# GUAM POWER AUTHORITY

AMENDMENT NO.: II

INVITATION TO BID NO.: GPA-021-26

GENERATOR REPLACEMENT AT THE GUAM MEMORIAL  
HOSPITAL AUTHORITY

For the Generator rating 2 MW, ATS at minimum typically be at 3000 AMPS at 480V 4 pole.  
Please see current ATS model numbers below:

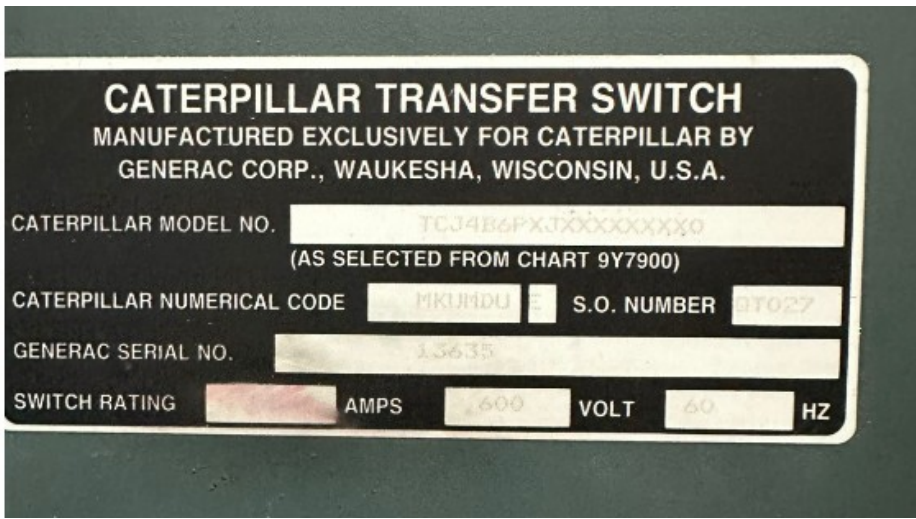
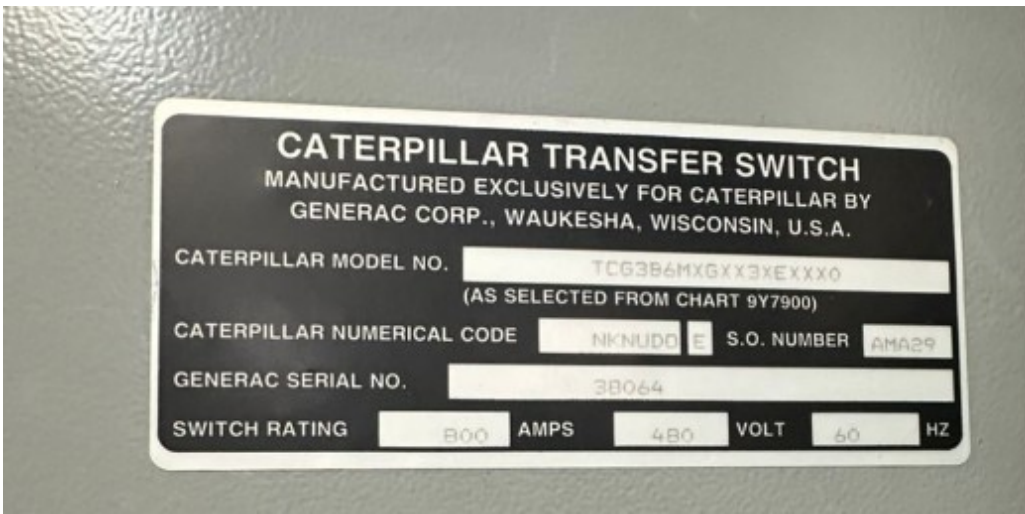
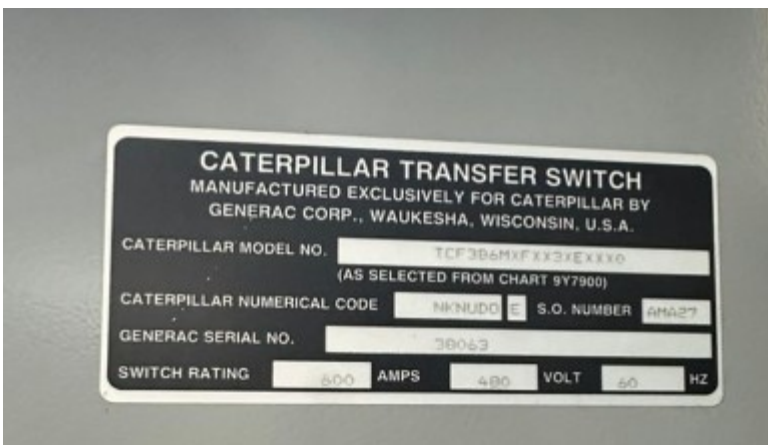
2. Page 16 of 138, #13 - Please provide specs on the New ATS system, so we can determine what is needed on the generator side for connection.

Please refer to the above CHANGE No. 1.b. If the Generator rating is 1.6 MW, then the ATS rating should typically be 2500 AMPS at minimum at 480V 4 pole.
